Palo Verde Nuclear
Generating Station

**Subject: Palo Verde Nuclear Generating Station (PVNGS)
Unit 1
Docket No. STN 50-528
Response to Request for Additional Information to Proposed
Exigent Amendment to Technical Specification 5.5.9, Steam
Generator Tube Surveillance Program**

**REQUEST FOR ADDITIONAL INFORMATION
PALO VERDE UNIT 1
TECHNICAL SPECIFICATION AMENDMENT - TUBESHEET INSPECTION
(Non-Proprietary Version)**

Figure 19-1

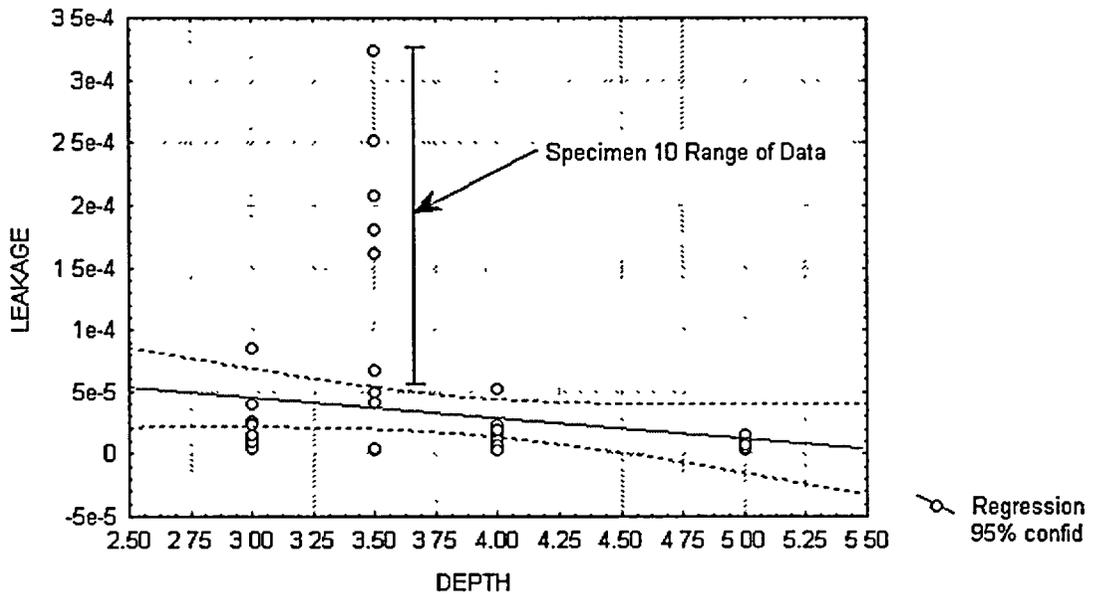
In Table 5-1 and Figure 5.1 of WCAP-15947-P the expected trend (increase in joint length results in a decrease in leak rate) does not appear to have occurred. Discuss the need for additional testing to explain the lack of a trend. Do you believe that the testing already completed has bound the largest potential leak rate?

As indicated by the NRC Staff, Figure 5.1 of WCAP 15947-P does not indicate a leak rate vs. joint length trend. However, APS believes that several observations can be made through a review of all the leakage data. Figure 5.1 of the WCAP and Figure 12 of the PVNGS Supplemental Report plot the average leak rate for the three (3) tests performed on each specimen. Additionally, APS in Figure 19-1 included the results of all the BE steam generator leak tests, as well as all the leakage test data from the single tube mockups. Although the 0.048 inch single tube mockup data is not considered applicable without adjustment for pullout criteria, the differences in tube wall thickness should not impact the leakage results. Plotting all the test data provides little improvement for relationship of joint length vs. leakage for the range of joint lengths tested. However as opposed to Figure 5.1, the test results illustrate that the leakage trend is flat for three (3) inch joints or longer with most values near the minimum level of detection for the CEOG test program.

Figure 19-1 also provides strong evidence that the data from Specimen 10 is not consistent with the rest of the data from over 60 data points. Additionally, as indicated the data spread for Specimen 10 ranges from a low of 4.13e-5 gpm to a high of 3.24e-4 gpm. An explanation for this anomaly could not be identified, although it was noted that the lower values were observed during a later test date. The most likely explanation for the outlier behavior is a bore surface finish that is uncharacteristic of the rest of the BE and rough bore mock-up samples. However, pull test data was not available for Specimen 10. Based on the outlying, variable and inconsistent nature of Specimen 10 results, APS concludes that the evidence supports removal of the ambient temperature test data for Specimen 10 from consideration.

The data presented in Figure 19-1 indicates that the contact forces due to expansion and internal pressure provide a satisfactory leak limiting joint at a three (3) inch joint length. As shown, the data is fairly flat for the 3, 3.5, 4 and 5 inch test samples, and most of the results are near the minimum level of detection for the test program. Furthermore, the major variability in the results is believed to be due to the test procedure itself. The test flow rates as described in Section 3.1.2 of WCAP 15947-P relied on counting pump strokes of a small capacity positive displacement pump over a minimum 40 minute test period. If no pump strokes were observed, a single pump stroke was assumed in order to include a flow rate in the dataset. Additionally, pump strokes were evaluated over the entire test period with no consideration as to when the positive displacement pump stroked during the test period. With most of the test data based on 0-4 pump strokes, considerable variability is introduced for such low leak rates.
